## MANDATORY SERVICE BULLETIN NO.

### MSB 40-103 / MSB F4-042 / MSB D4-114 / MSB 40NG-084

Actions to prevent Passenger Door Separation: Installation of Placards, AFM Procedure update and Inspection/Data Gathering.

Installation of passenger door placards and inspection of the passenger door system.

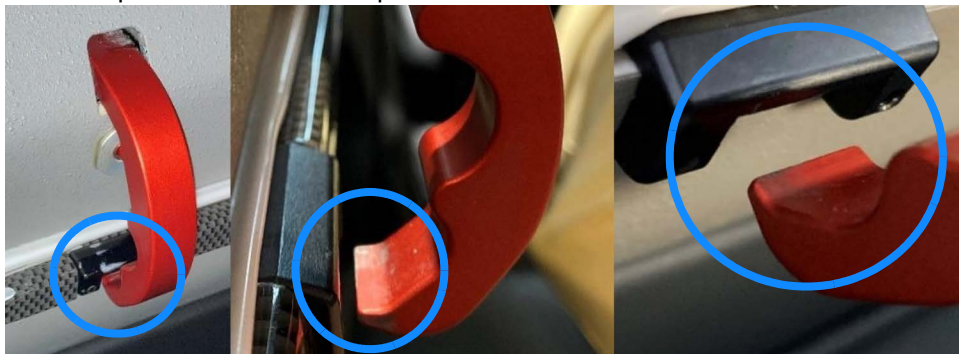
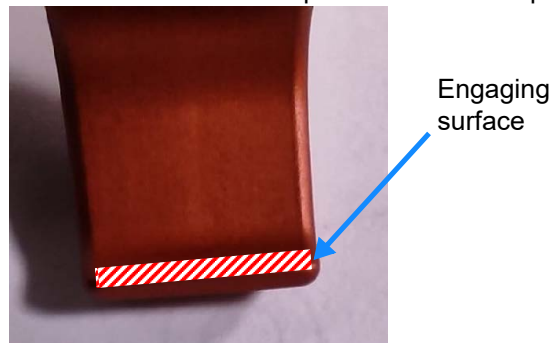
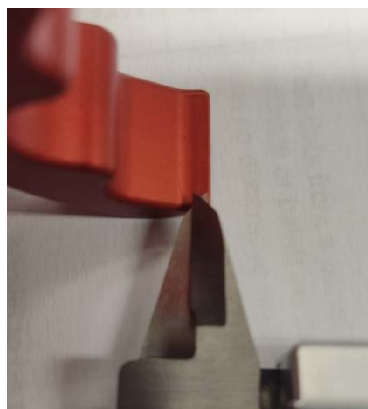
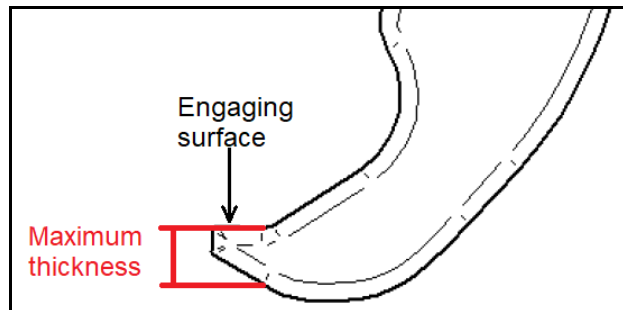
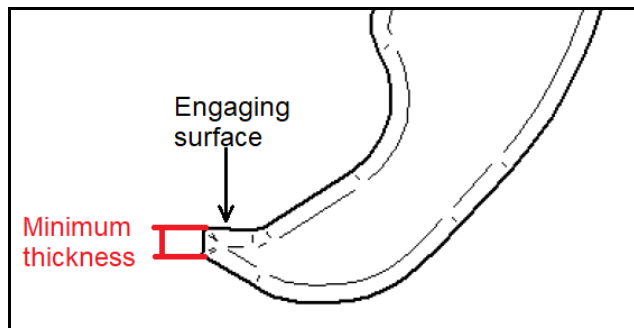
- a) Check the contact area of the push button.
- Grooves in the safety hook must be less than 2 mm deep.

- b) Examine the hook end of the safety hook.

- c) Examine the tip of the safety hook for wear:
- Wear of edges of safety hook.
  - The width of the tip of the safety hook must be greater than 10.5mm.

- d) Examine the engaging surface of the safety hook, which is the plane surface at the tip of the safety hook.
- It must not have any steps and ridges.
  - Scratches or uniform wear of surface protection are acceptable.

- e) Measure the width of the engaging surface.
- The width must be greater than 1.5 mm.

- f) Measure the maximum thickness of the safety hook at the location of the engaging surface, perpendicular to the engaging surface.
- The maximum thickness must be greater than 2.5 mm.
  - The the variation of thickness measured along the width of the safety hook must be less than 0.2 mm.

- h) If the safety hook does not meet one or more of the acceptable conditions listed above on sub-steps **a** through **g**, take note to replace the safety hook after this WI is completed. Refer to Section IV for replacement of the safety hook.

Figure 2.

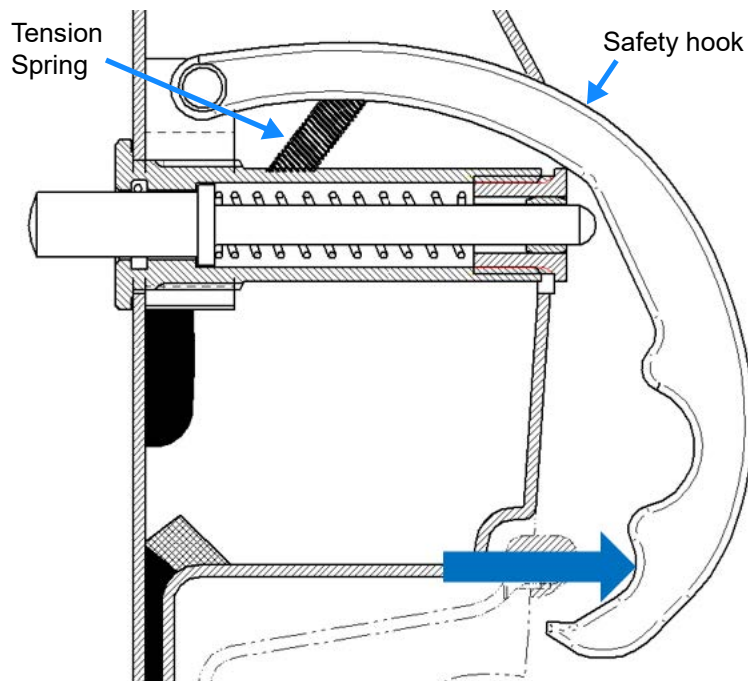
6. Check the condition of the tension spring and the force to lift the safety hook from its resting position as follows:  
Refer to Figure 2.
- a) Open the passenger door.

- b) Examine the tension spring of the safety hook. Use a borescope through cutout in the door, if corrosion, deformation or damage is found, take note and replace it after this WI is completed. Refer to Section IV for removal and installation of the hook assembly.

- c) Lift the safety hook and release it.
    - After releasing the force, the safety hook must snap back into its resting position.
    - If the safety hook does not snap back into its resting position, do the following:

Small (DA4-5200-00-69)

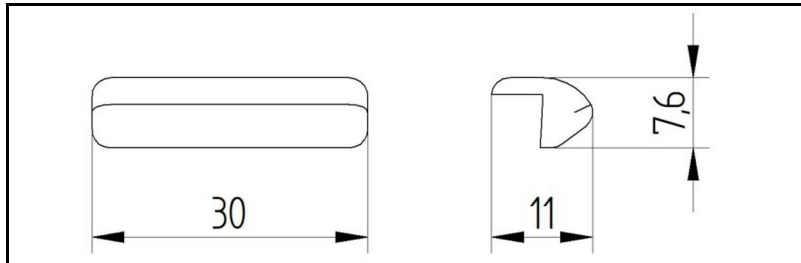
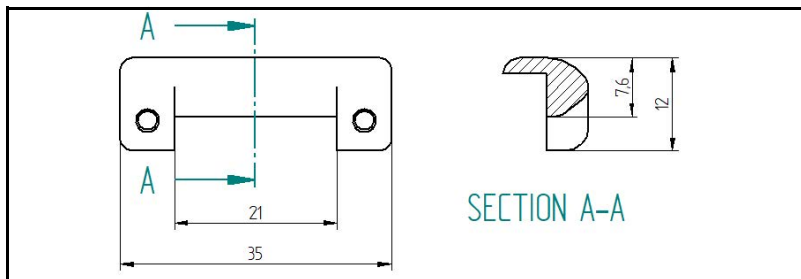
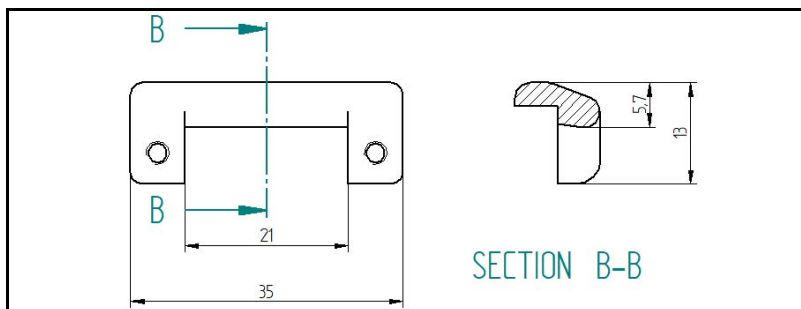
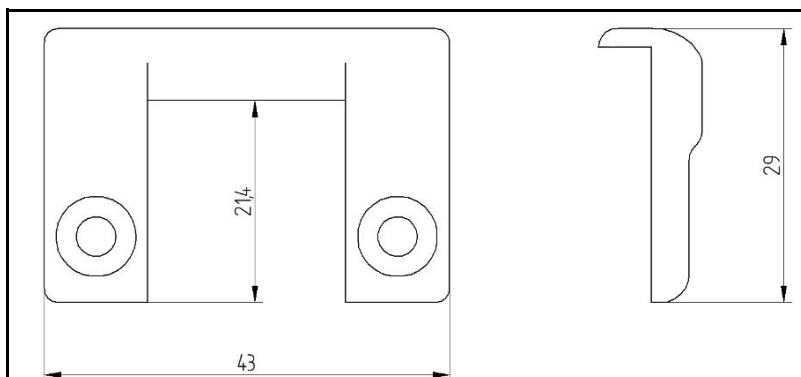
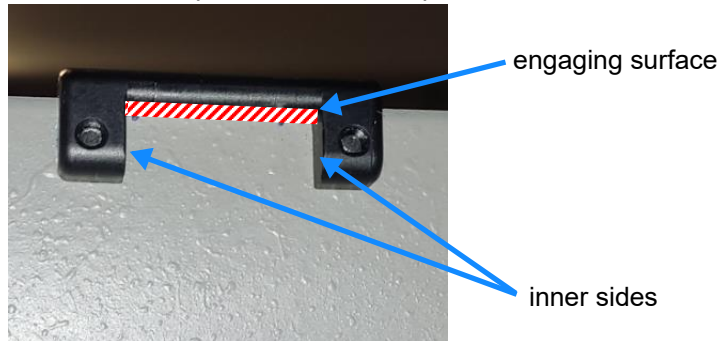
7. Identify the version of the retaining block:  
 Record the version in the execution report.

Figure 4.

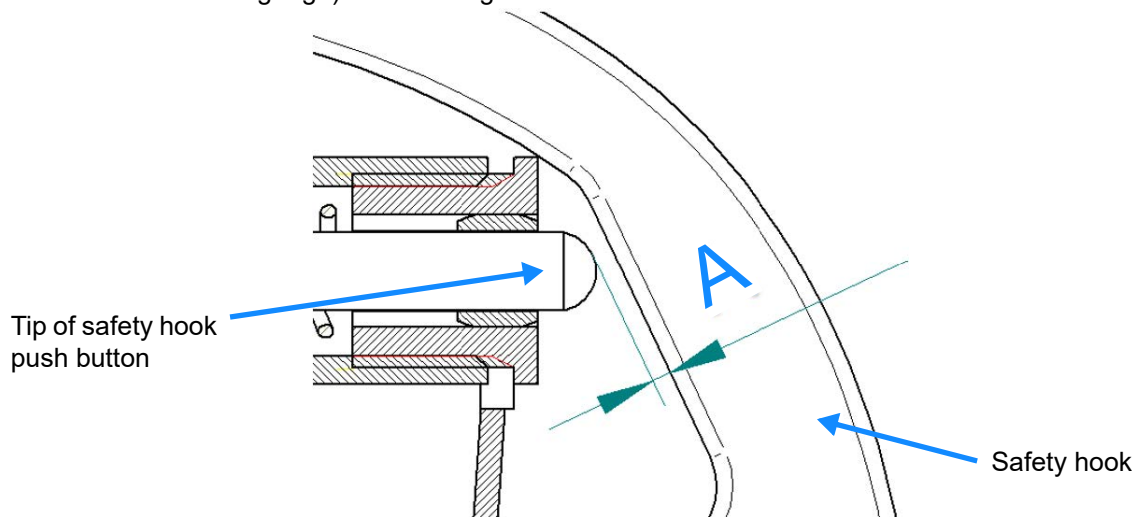
- b) Record the measurements on the execution report in Appendix A.
- Dimension A: distance of push button to the safety hook in resting position (e.g. with a feeler gauge). Refer to Figure 4.

Figure 5.

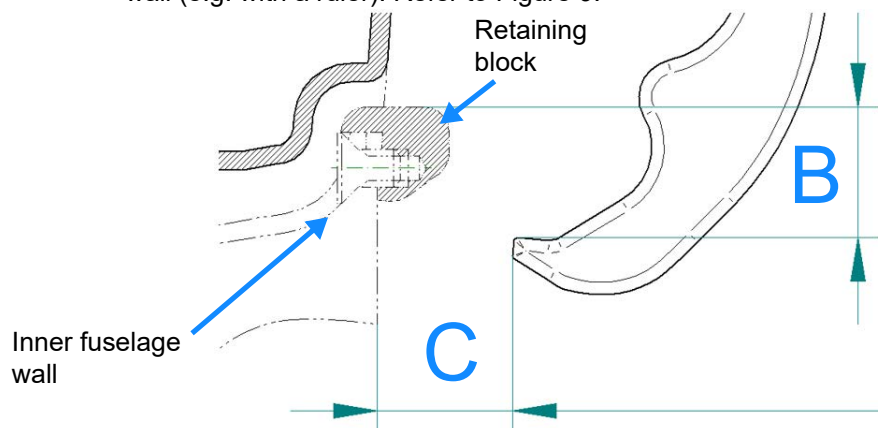
- Dimension B: distance between the top surface of the retaining block to the top surface of the engaging section of the safety hook in resting position (e.g. with a ruler). Refer to Figure 5.
- Dimension C: horizontal distance between the tip of the safety hook and the fuselage wall (e.g. with a ruler). Refer to Figure 9.

Figure 6.

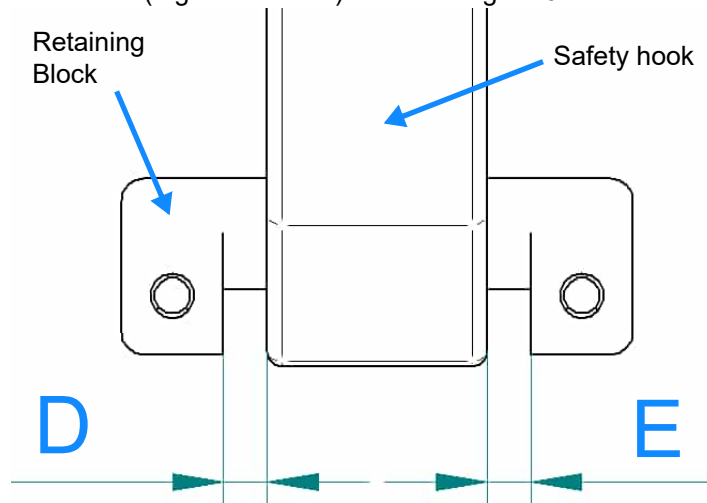
- Dimensions D and E (e.g. with a ruler). Refer to Figure 6.

Figure 10.

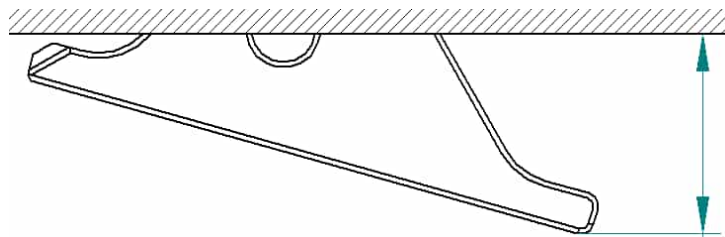
15. If the old passenger door latch is installed (refer to step 14), visually inspect the spring:  
Refer to Figure 10.
- Move the passenger door handle to the unlatched position.
  - Visually inspect the spring.
    - Look specifically for a broken winding, replace the spring if found broken.
  - Record any findings on the execution report in Appendix A.

Figure 11. Protrusion measurement

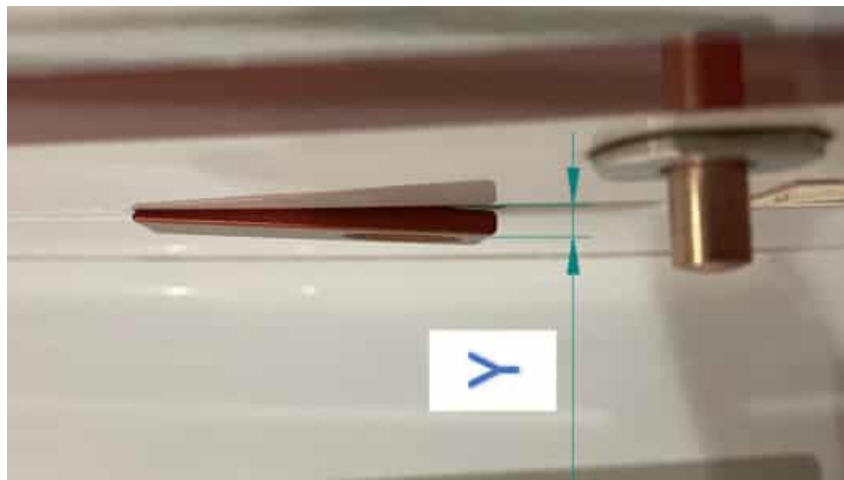
19. Data collection: Position of the external passenger door handle. Refer to Figures 11 and 12.
- Close the passenger door.
  - Push the external passenger door handle into the latched position until it stops.
  - Examine if the passenger door handle is recessed, flush or protruding over the passenger door surface.
  - Record the condition of the passenger door handle on the execution report in Appendix A.
  - If the handle protrudes from the surface of the passenger door, measure the protrusion.
  - Record the measurement on the execution report in Appendix A.

Figure 18. Example of **NOT** acceptable condition of door guide block

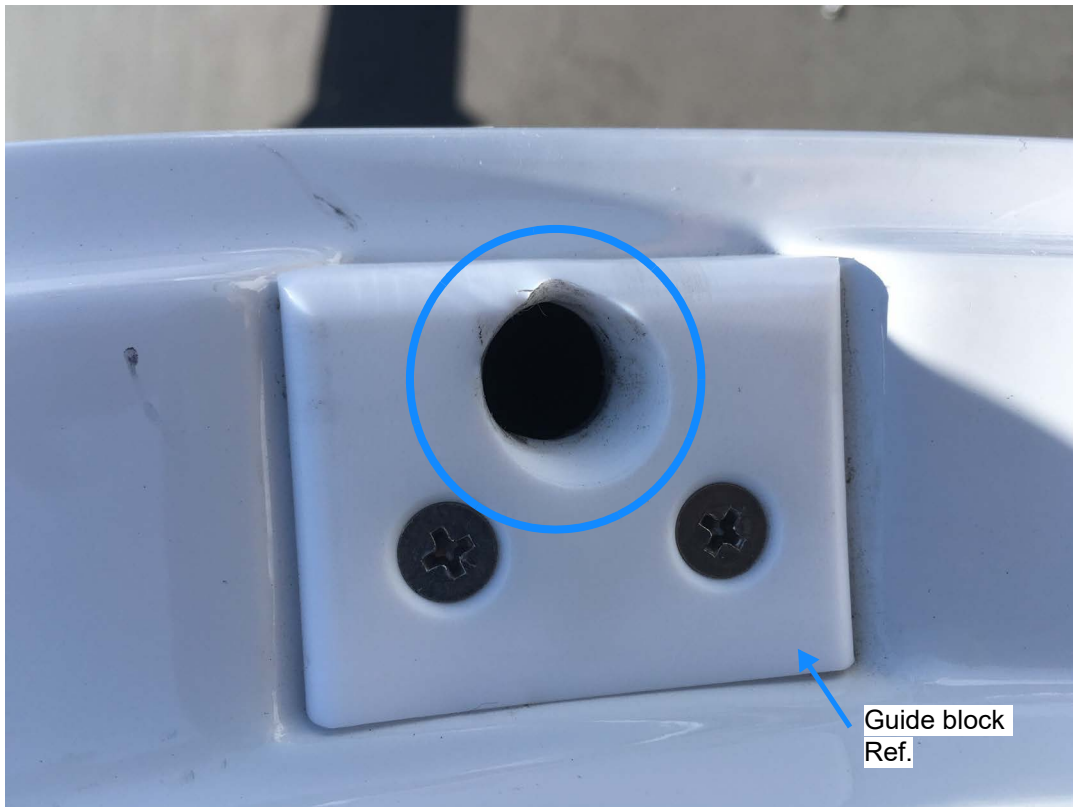
23. Inspect the front and rear door guide block for damage. Refer to Figure 18.

- a) Open the passenger door.
- b) Visually check the condition of the guide block.
  - The guide block must not have worn edges, dents, cracks.
  - If you found any damage, take note and replace the guide block after the WI is completed. Refer to section IV for the replacement.
  - Record any damage of the guide blocks on the execution report in Appendix A.

Figure 29.

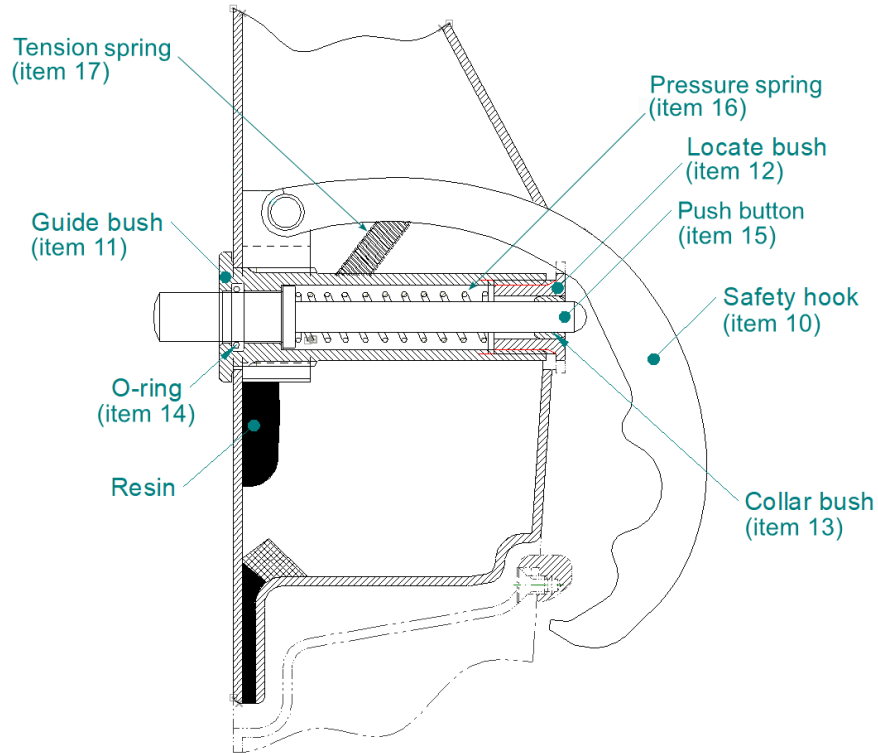
Refer to Figure 29.

NOTE: To replace the safety hook or push button, the hook assembly (safety hook and push button) needs to be removed from the airplane and taken to a work table for disassembly.

1. Remove the inner door handle to get access to the inside of the door. Refer to AMM Section 52-10.
2. Unscrew the guide bush and locate bush to release the push button assembly.

3. Remove the hook assembly from aircraft through the handle opening and place it on a work table to replace safety hook.
4. Remove screw that secures the tension spring on the safety hook.
5. Remove cotter pin to release safety hook, pin and washers.
6. Install the new safety hook (item 10) using the pin, washers and cotter pin.
7. Reinstall tension spring using the screw to secure it. Use Loctite 262 (item 6) to screw, refer to manufacturer instructions for proper use.
